Diagrams for amendments to ECE/TRANS/WP.29/GRSG/2011/19 -
Regulation No. 58 (Rear underrun protection)

Diagram 1: Cases where the change in the RUPD height from 100 mm to 150 mm will be difficult (Vehicles with retractable tailgate lift)

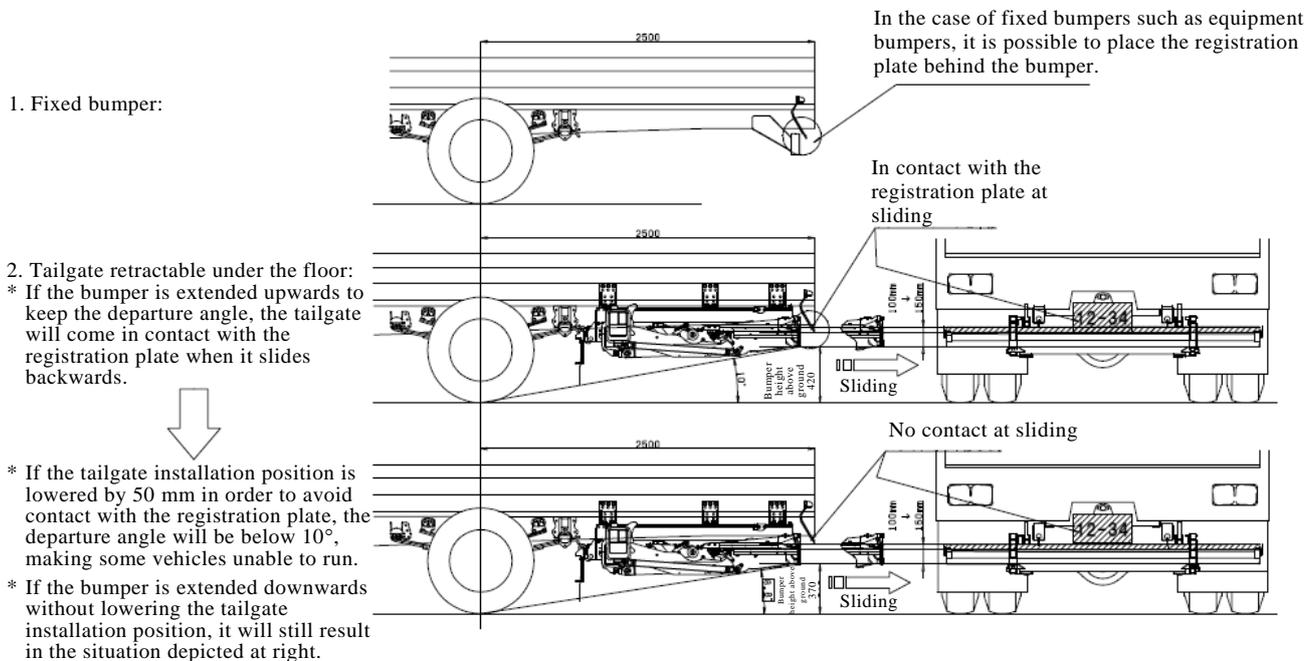
Due to the size of Japanese registration plates, the RUPD cannot be extended upwards, and if it is extended downwards, it will result in an undesirable departure angle which causes the RUPD to come in contact with the road surface. Even in the case of vehicles with a short ROH, the RUPD will come in contact with the road surface when the vehicle enters parking lots. (Contact with the road surface occurs when the departure angle is 10° or below.)

Diagram 2: Cases where the departure angle of 10° or above is necessary

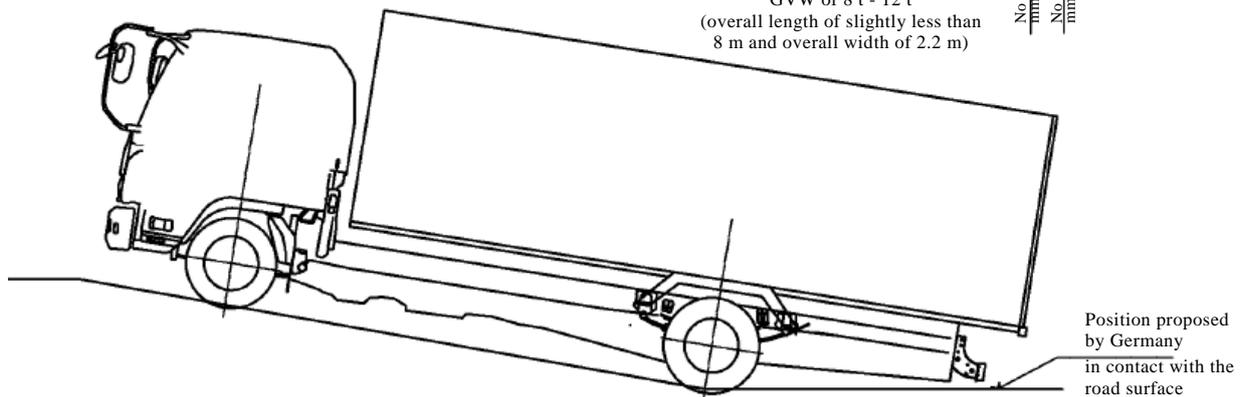
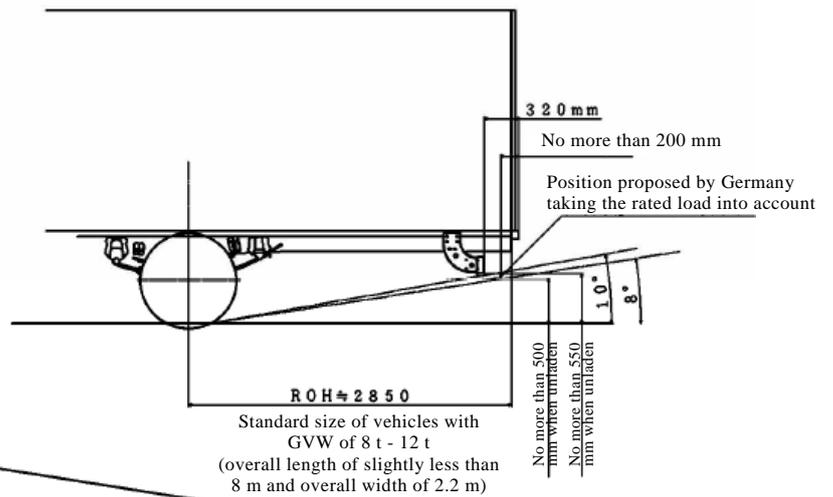
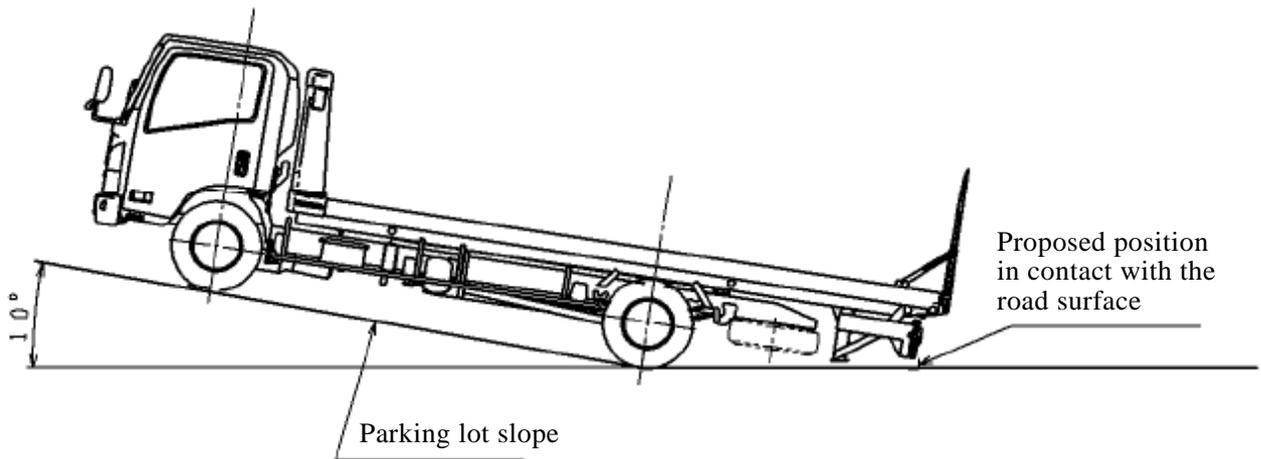
From the standpoint of practicability on the market, the departure angle of 10° is specified. If it is 8°, the RUPD will come in contact with the road surface while the vehicle is running, making it unable to keep running. For medium-sized vehicles, some manufacturers in Japan have established voluntary regulations regarding the departure angle as these vehicles often enter parking lots and/or narrow streets. (The cases where they came in contact with the road surface at a departure angle of 9° or below have been reported.)

Diagram 3: Cases where the departure angle of 10° or above is necessary (Car carrier vehicles)

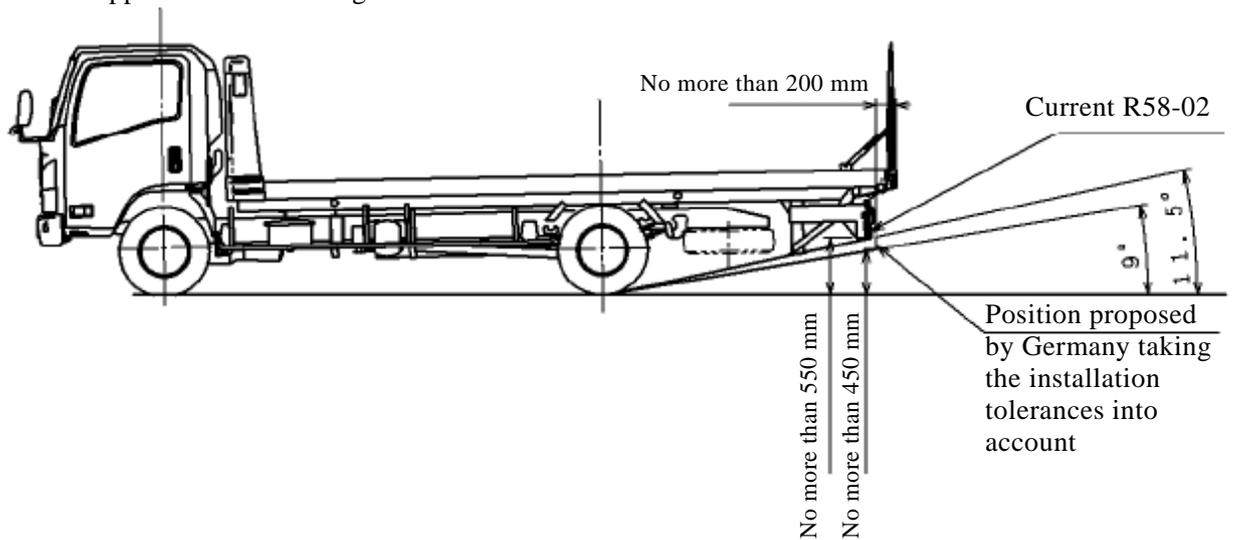
The RUPD will come in contact with the road surface while the vehicle is running, making it unable to keep running. (The device will come in contact with the road surface when the vehicle enters parking spaces in urban areas, etc.)

Diagram 4: Cases where the RUPD installation position of 200 mm will cause technical problems in constructing the vehicle structure (Vehicles with platform tailgate lift)

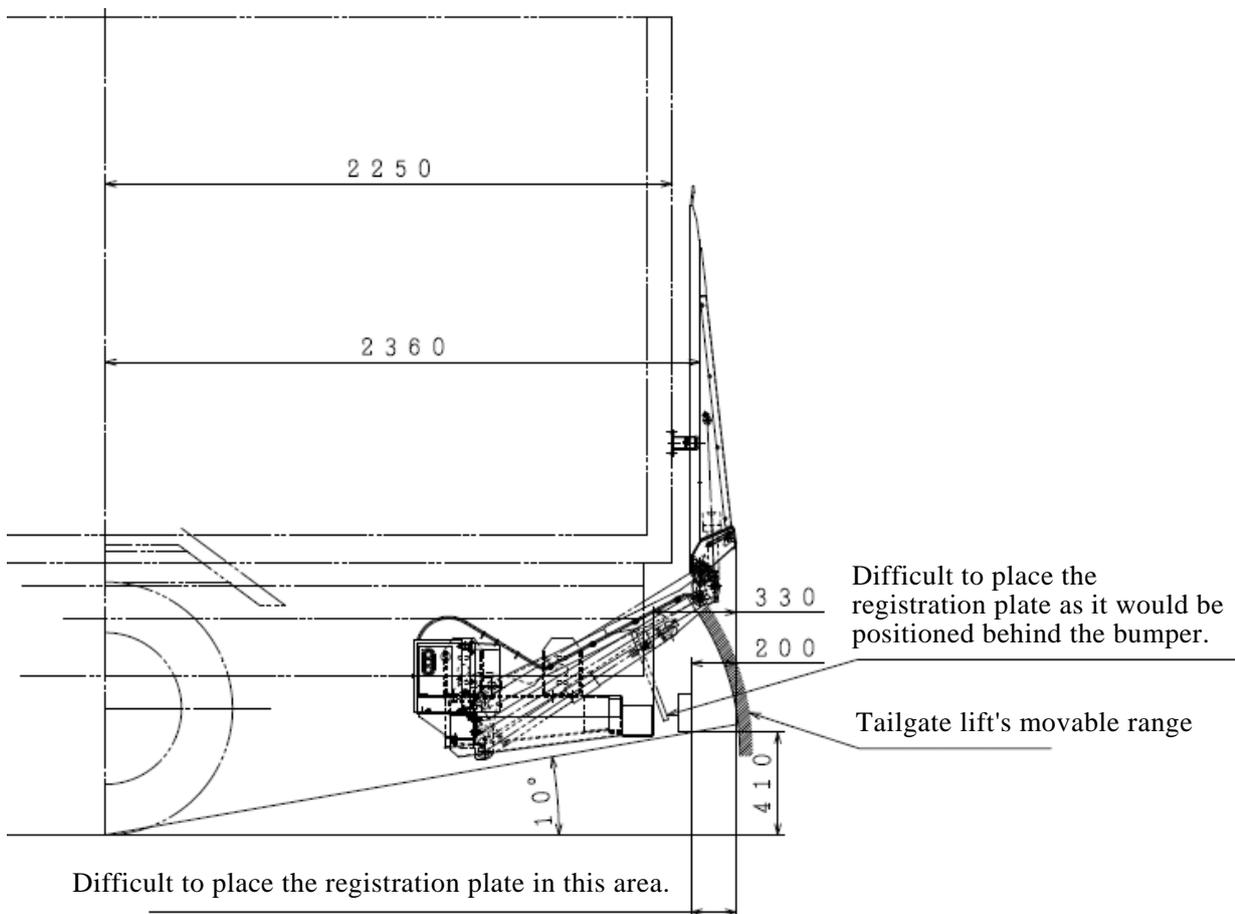
If the horizontal distance between the vehicle's rearmost part and the RUPD installation position is set at 200 mm or less:

The registration plate will be located behind the RUPD, which leads to non-compliance with the registration plate visibility requirement. The proposed amendment to paragraph 25.2 says "For vehicles fitted with a platform lift at the rear the distance may not exceed 300 mm." However, the current distance 330 mm does exceed 300 mm, and the reality is that the registration plate is placed in such a limited space. For this reason, the distance of 350 mm is necessary for vehicles with tailgate lift.)

Figure 1 Contact Caused by Dumping

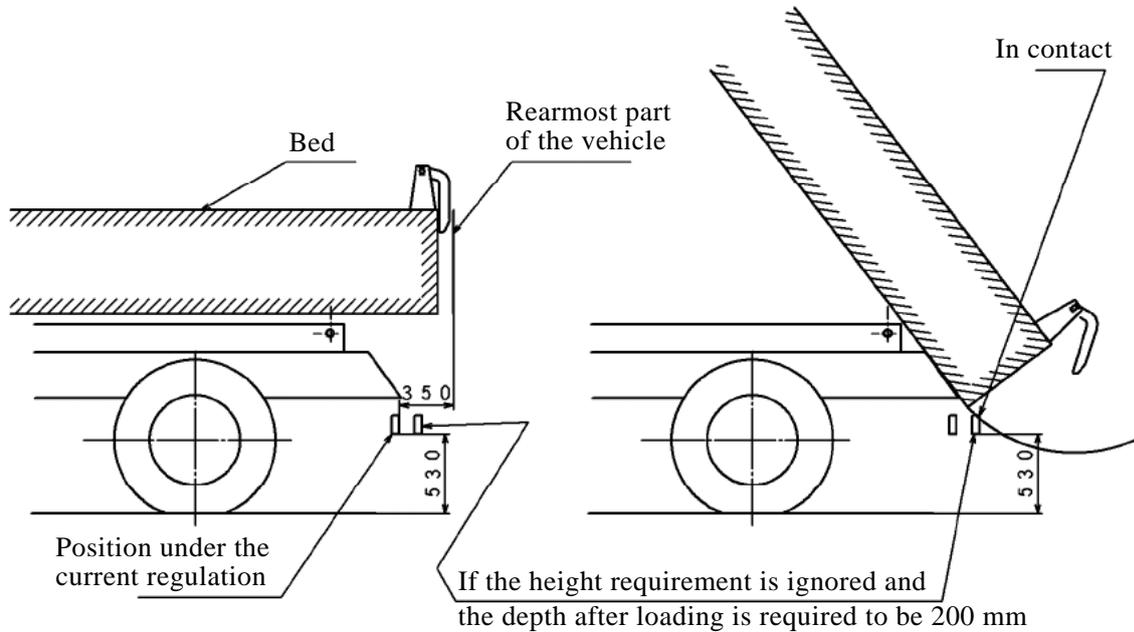
1. The bed will come in contact with the RUPD when it rises for dumping, which makes the structure impossible. (Figure 1)

Figure 2 RUPD Entering the Deposits of Dirt at Dumping

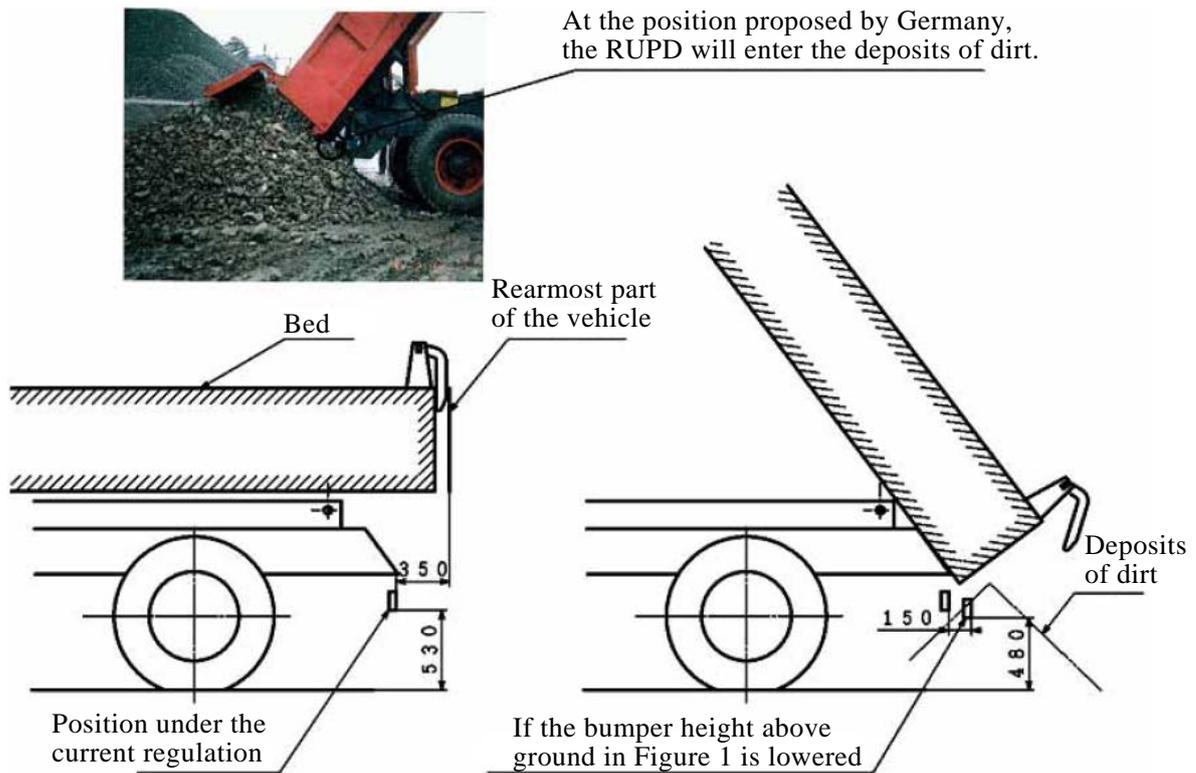
2. If the bumper is lowered, the dumped deposits will push the RUPD and cause danger. It will also enter the deposits of dirt and cannot escape easily. (Figure 2)

3. The possibility of the dumped deposits damaging the RUPD will increase, which will raise the frequency of the vehicles running with the damaged RUPD, compromising safety. (Figure 2)

Figure 3 If the Dump Bed Length Is Shortened

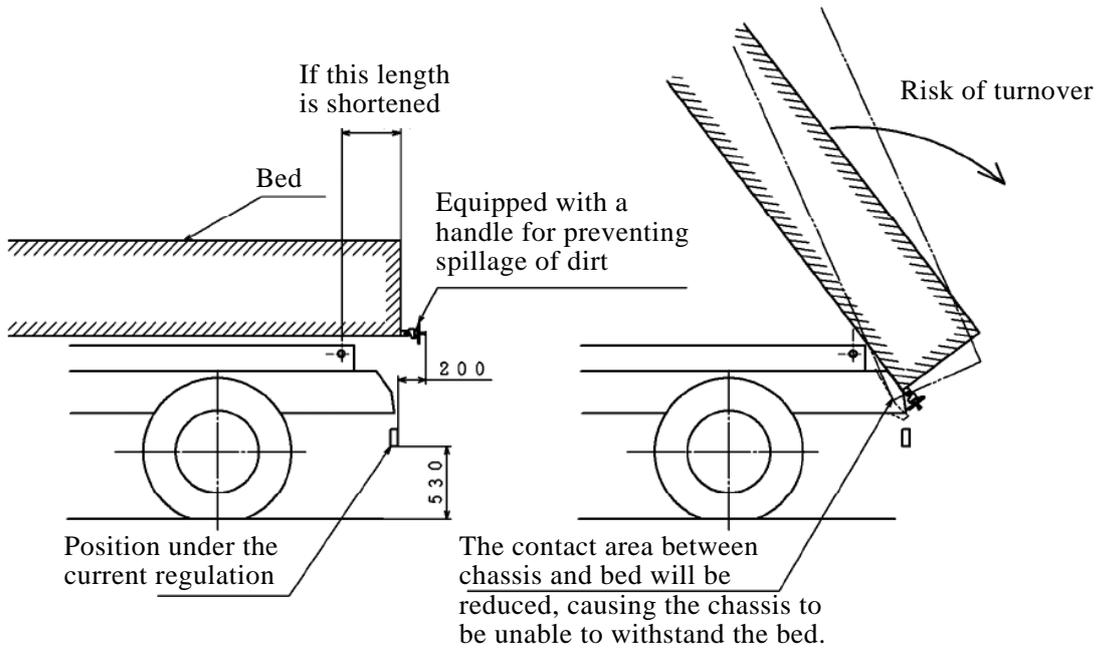
4. With the distance from the RUPD being shorter, the distance from the dump hinge will also be made shorter. This will lead to malfunctioning of the stopper function in the event of over-dumping, causing damages to the chassis and risk of turnover. (Figure 3)

Figure 4 Unable to Run on Unpaved Roads in Construction Sites, Dump Yards, etc.

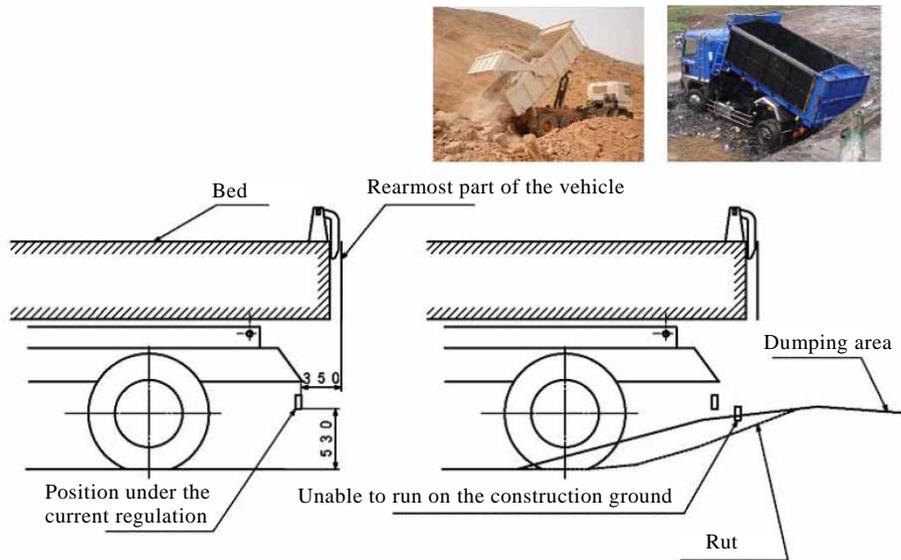
5. On unpaved roads (construction sites), the RUPD will come in contact with uphill slopes to work sites, ruts, etc., making it difficult for the vehicle to keep running. (Figure 4)

Figure 5 Pit Dumping Diagram (showing why the proposed depth of 200 mm is difficult)

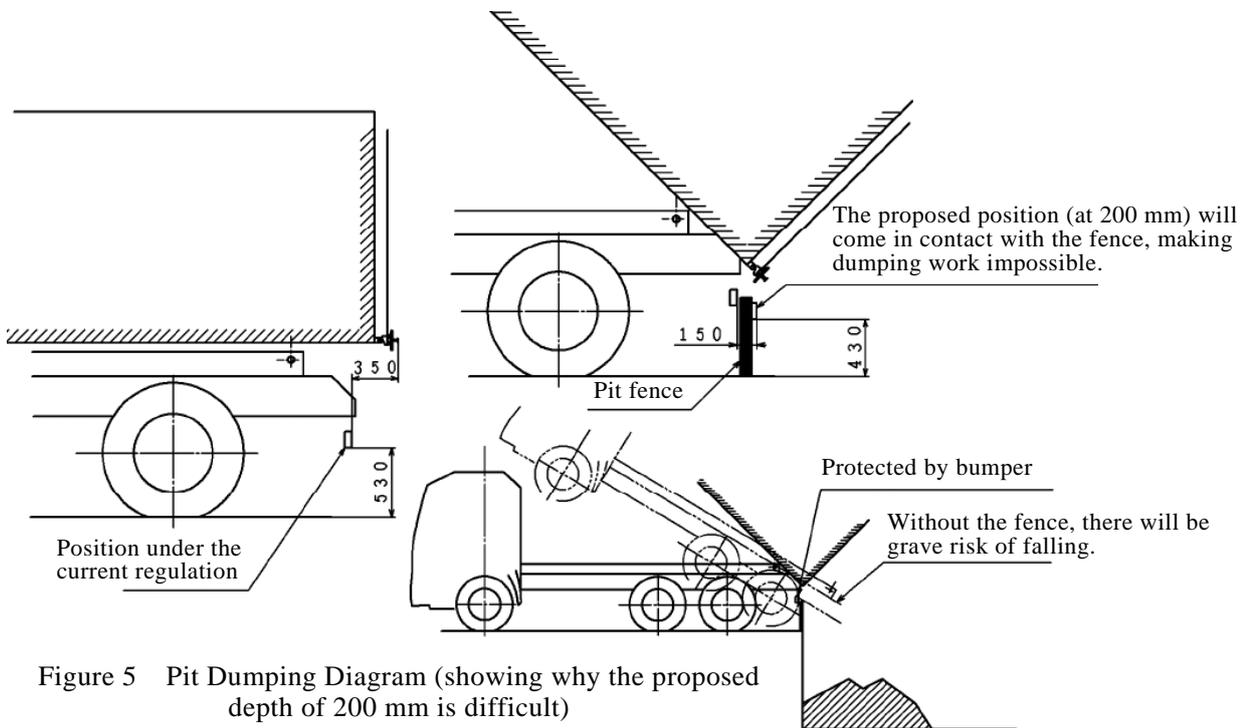
6. In the case of dump trucks for industrial waste that perform pit dumping, the RUPD will come in contact with the fence for the prevention of falling, causing difficulties in dumping work. It will also cause danger if the fence on the pit side is lowered. (Figure 5)

Diagram 6: Cases where the RUPD underside height of 500 mm will cause difficulties in usage (Concrete mixers)

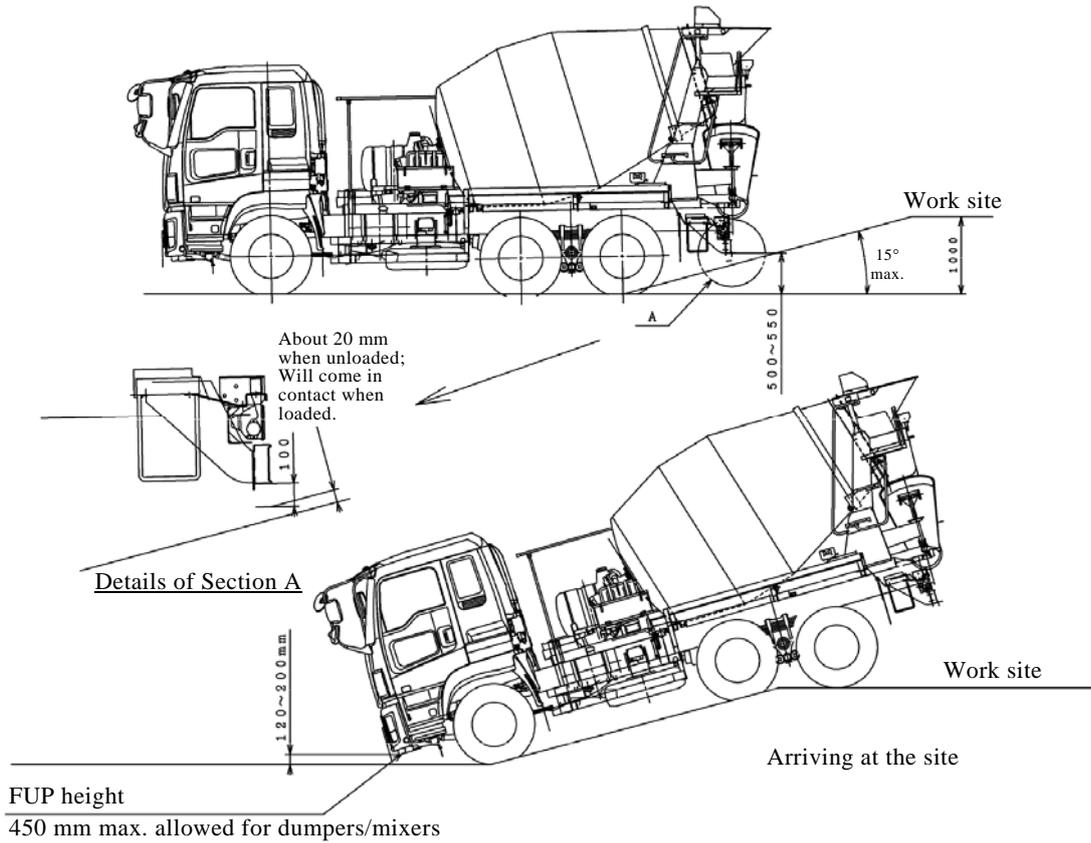
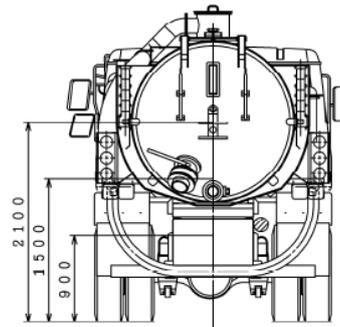
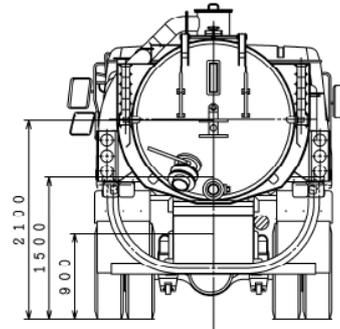
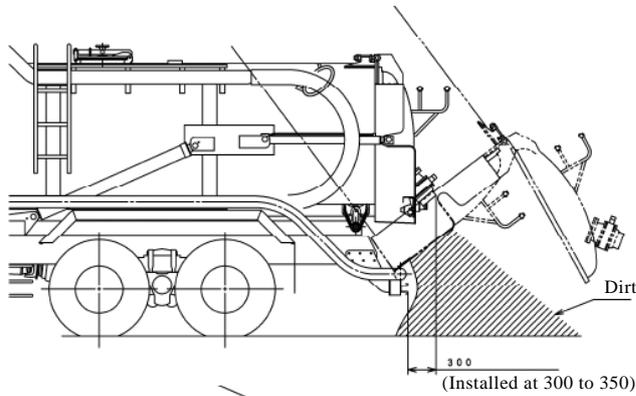
In Japan, some of these vehicles are stored on hills, where the maximum gradient can be around 15°. The RUPD will come in contact with the road surface while the vehicle is running, making it unable to keep running to enter the site.
